LAND DEVELOPMENT TEAM (LDT) APPLICATION RESPONSE LETTER, SUBMITTAL # 3

PROJECT ADDRESS: 505 East Los Olivos Street
PLN RECORD #: PLN2024-00299
DATE: Wednesday, January 15, 2025 – Review # 3
APPLICANT: Ben Eilenberg, THE MISSION LLC
socialindustrialequities@gmail.com
ASSIGNED PLANNER: Barbara Burkhart, BBurkhart@SantaBarbaraCA.gov
STATUS: INCOMPLETE

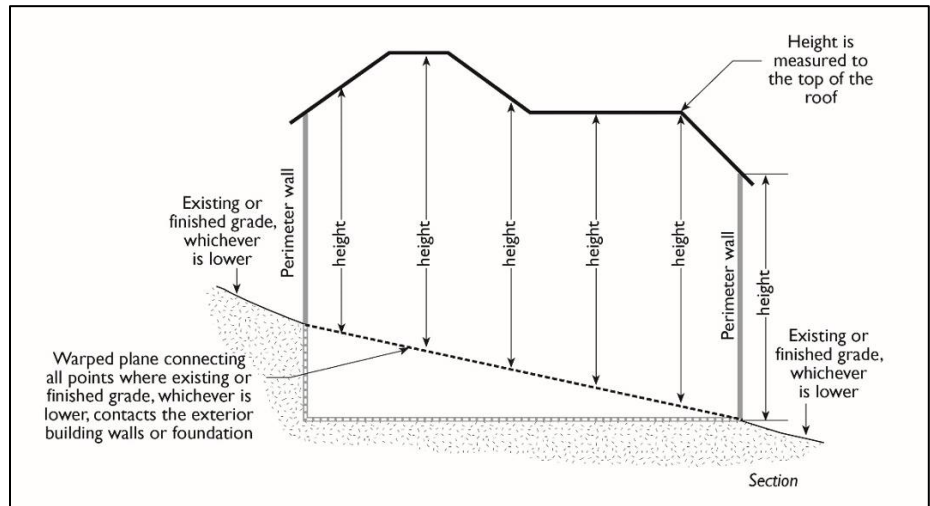
~~Show the Site Visibility Triangle per SBMC §[30.140.230](#), Visibility at Driveways and Intersections. Your response letter indicates that this information is provided on the Civil Sheets, however it is not provided on any sheet in the plan set. See below for further clarification on how to depict this on the plans.~~

~~• **SBMC §30.140.230.B Driveways.** Visibility at a driveway that crosses a front property line shall not be blocked above a height of 42 inches within the triangle areas described below:~~

- ~~1. **Street with Sidewalk and Parkway.** When a driveway directly abuts a portion of a street with a sidewalk and parkway, the triangle is measured on two sides by a distance of 10 feet from the side of a driveway and 10 feet back from the front lot line.~~
- ~~2. **Street without Sidewalk and Parkway.** When a driveway directly abuts a portion of a street without a sidewalk and parkway, the minimum required site distance is established based on legal vehicle speed and the position of the driver's eye in relation to the intersection as determined by the Public Works Director. The Public Works Director may require additional site distance due to site specific conditions.~~

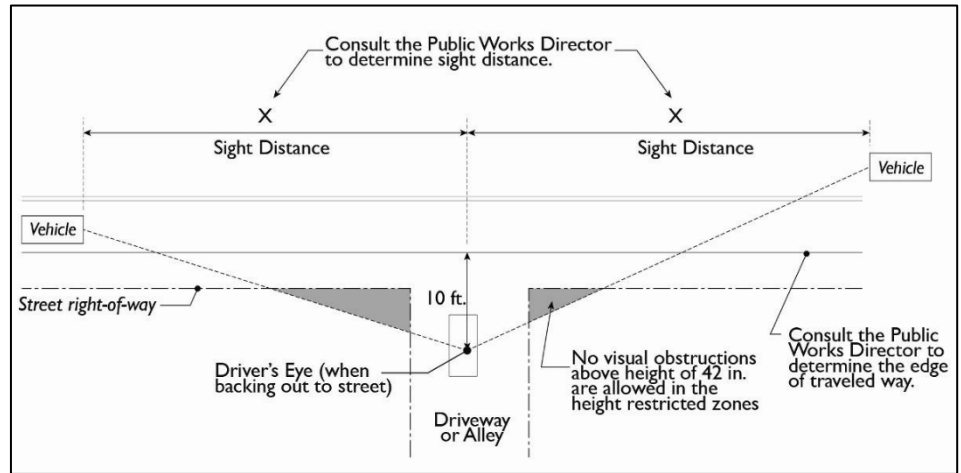
- The Conceptual Irrigation Legend (called the Irrigation Schedule in the previous submittal) on Sheet CI-1 is inconsistent with the Conceptual Irrigation Legend ~~Irrigation Schedule~~ on Sheet CI-2. Your response letter indicates that the Conceptual Irrigation Legends have been reconciled; however, Zone 3 and Zone 7 colors remain inconsistent. Please reconcile. (Moved from Section III, Additional Information Required)

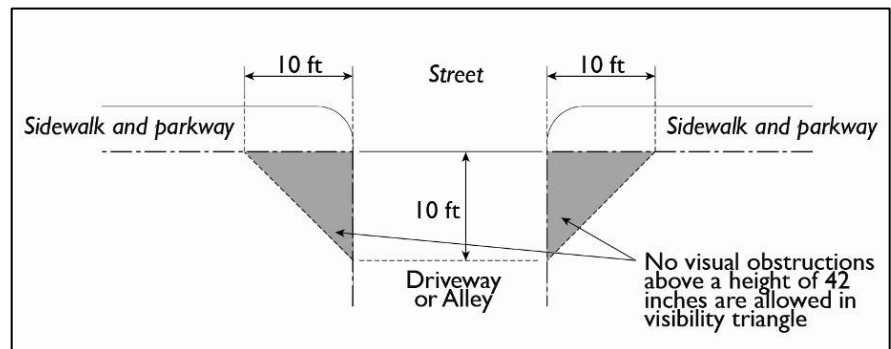
~~information is provided on the Civil Sheets, however it is not provided on any sheet in the plan set.~~ See below for further clarification on how to depict this on the plans.

- **SBMC §30.140.230.B Driveways.** Visibility at a driveway that crosses a front property line shall not be blocked above a height of 42 inches within the triangle areas described below:

- **Street with Sidewalk and Parkway.** When a driveway directly abuts a portion of a street with a sidewalk and parkway, the triangle is measured on two sides by a distance of 10 feet from the side of a driveway and 10 feet back from the front lot line.

Figure 1. Floodplain and Floodway Outlines

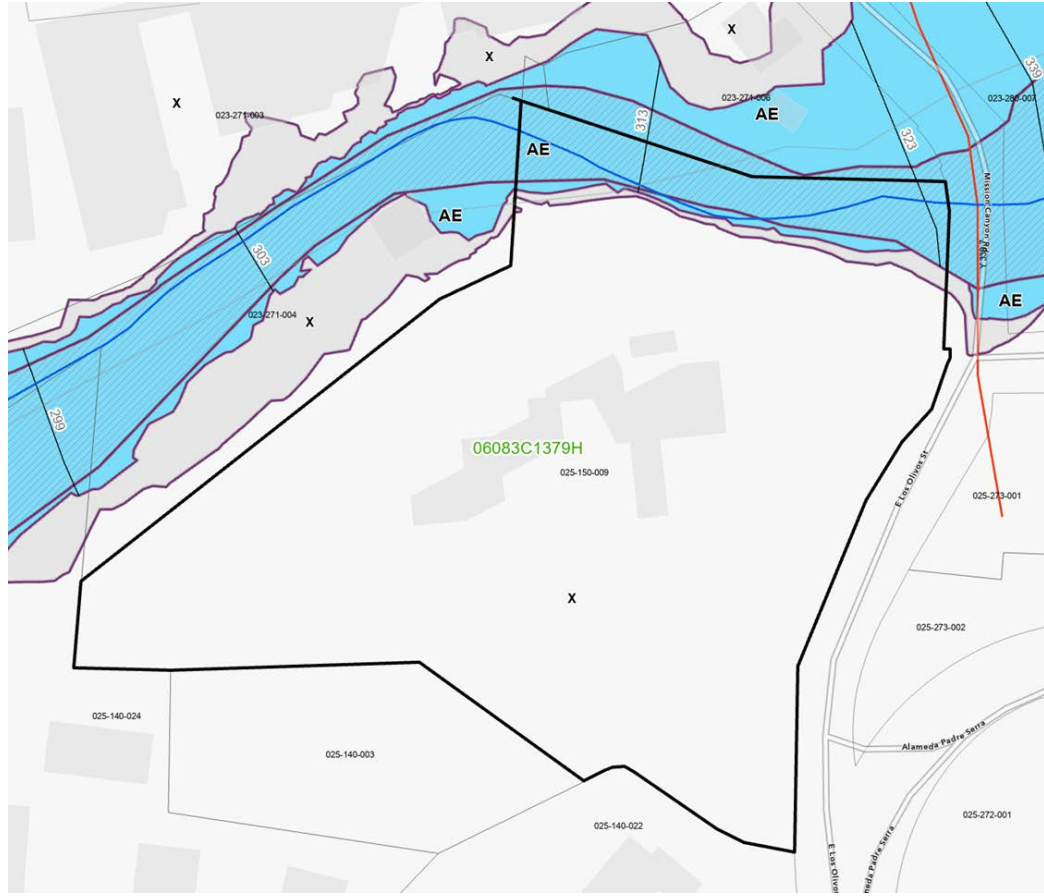
Provide a site civil engineering drawing locating the Regulatory Floodway and Floodway Fringe boundaries.

- b. Accurately show the AE floodplain and the AE floodway (hatched), as identified in Figure 2 below, on Sheet A.0.01. Identify all proposed structures, buildings, flat work, and site walls on this plan.
